UNITED STATES PATENT AND TRADEMARK OFFICE

APPLICATION NO.	FILING DATE	FIRST NAMED INVENTOR	ATTORNEY DOCKET NO.	CONFIRMATION NO.
10/765,825	01/26/2004	James A. Mann JR.	DSCK-1246-C1	9085

Office Action Summary

DETAILED ACTION

enclosure (1)

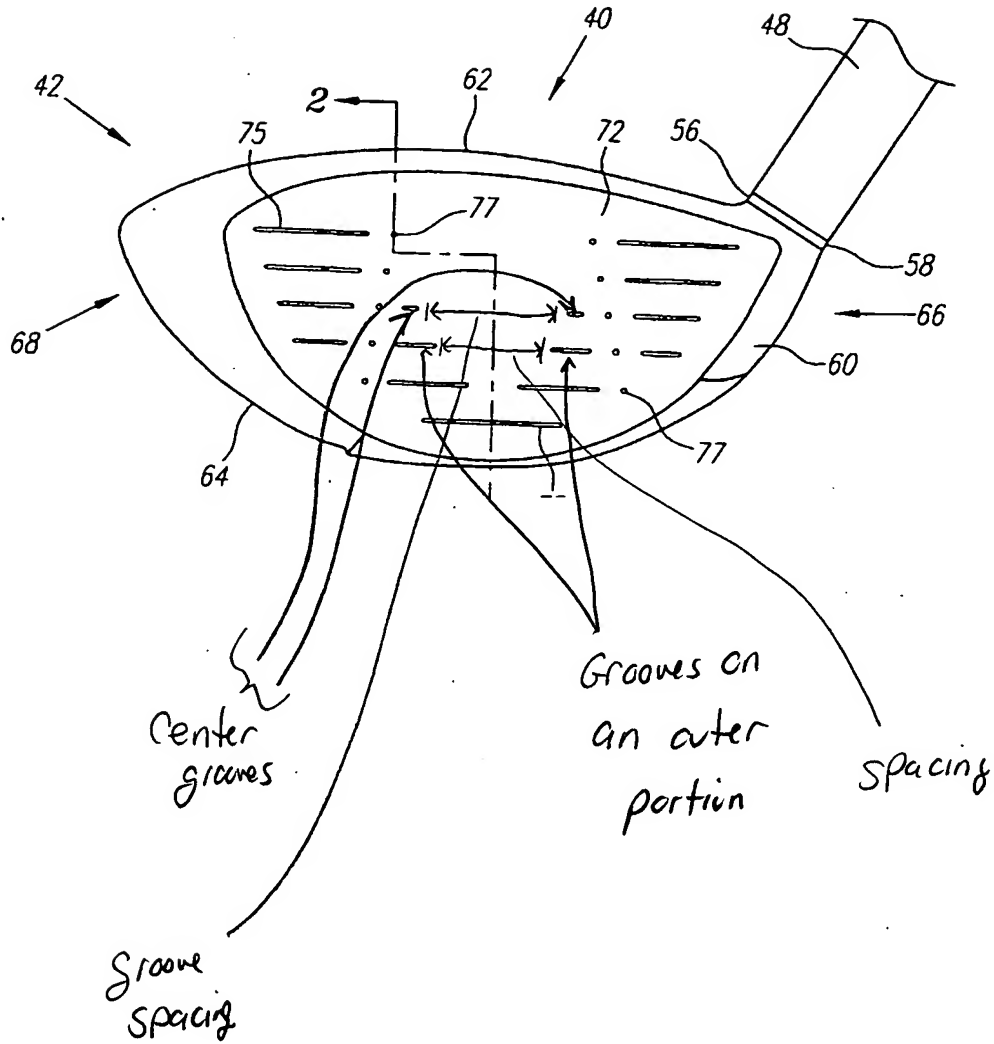
Galloway discloses a plurality of center grooves having a groove spacing of about 5 to 50 % greater than grooves placed on an outer portion of a face (See enclosure (1)) and a compared wood being a 1 club configuration in the form of a driver (Col. 4, Lns. 40-55).
